Design Review Board Case #2016-0001
Carlyle Plaza Two – South Residential Building

MEMORANDUM

SUBJECT: CARLYLE PLAZA II – SOUTH RESIDENTIAL TOWER NOVEMBER DRB SUBMISSION

Staff Direction

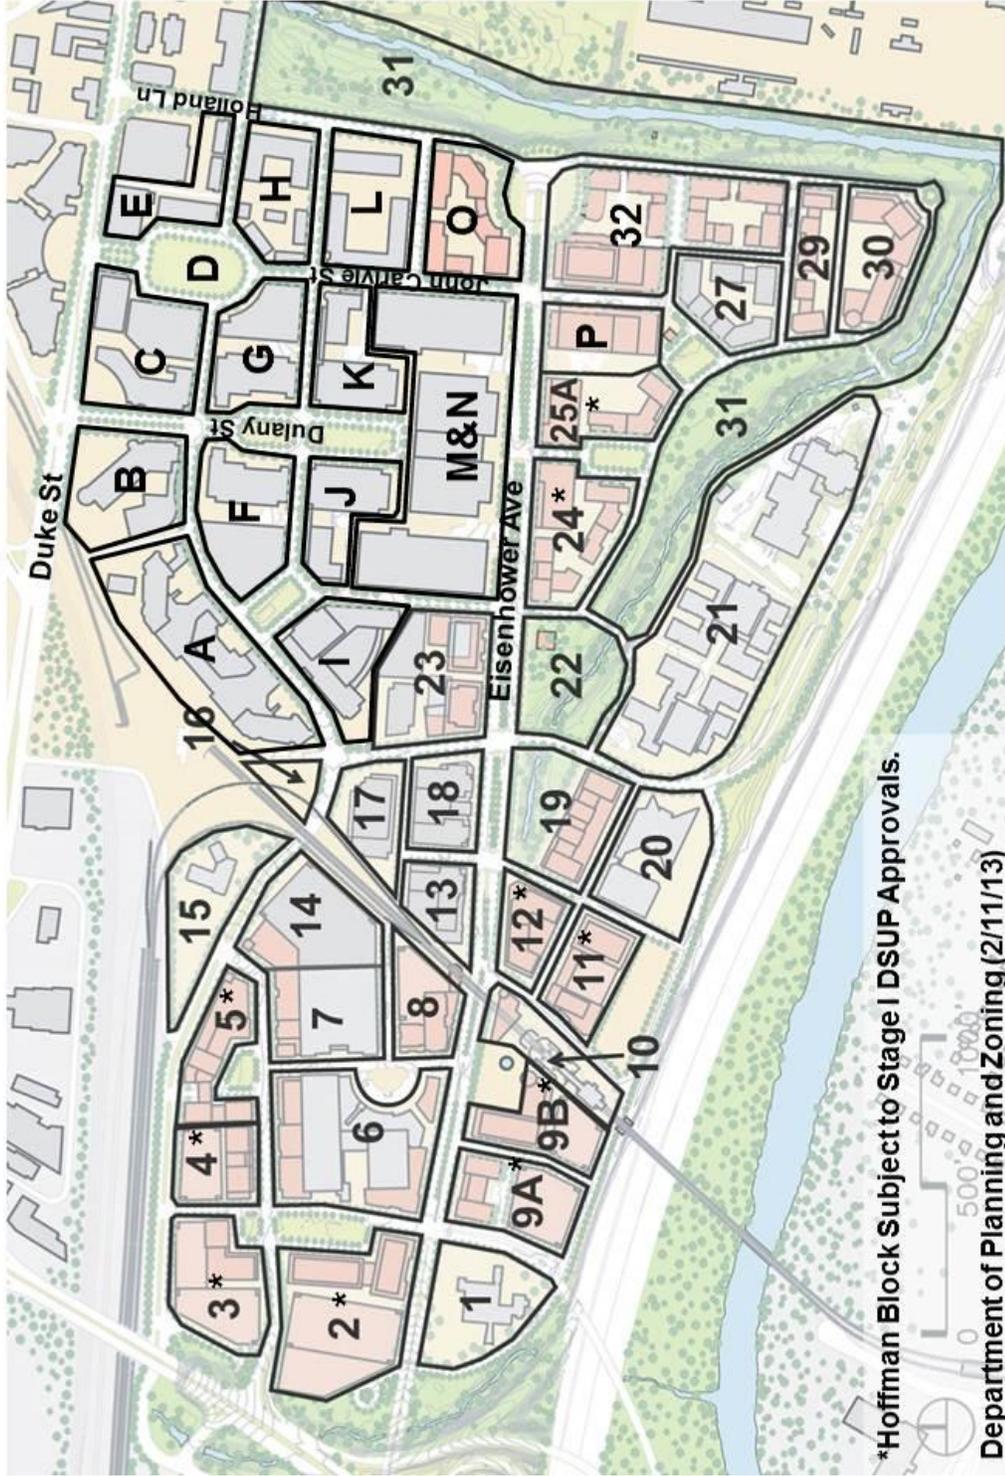
1. Utilize vision glass as presented in approved renderings, except for the portion concealing penthouse mechanical spaces.
2. Staff continues to have concerns that the East/West slots are not sufficiently visually distinct from the surrounding architecture.

3. Adjust balconies or units to eliminate privacy conflicts and the use of physical barriers within balconies.
4. Resolve privacy issues between public and private terraces on 16th and 26th floors. Provide details requested (see above).

5. Return pilotis design to the approved version incorporating circular columns with consistent spacing.
6. Provide architectural lighting in the garage and provide visual barriers where the parking levels overlook the street.

7. Identify the soffit material, patterning and any lighting used beneath the 16th and 26th floor projections.
8. Provide a timeline for use of the “future staging area,” describe and show screening provided.

9. Show the overhangs of the building that create the “front porch” at the pool level in plan view by using a dotted line or other graphic convention.
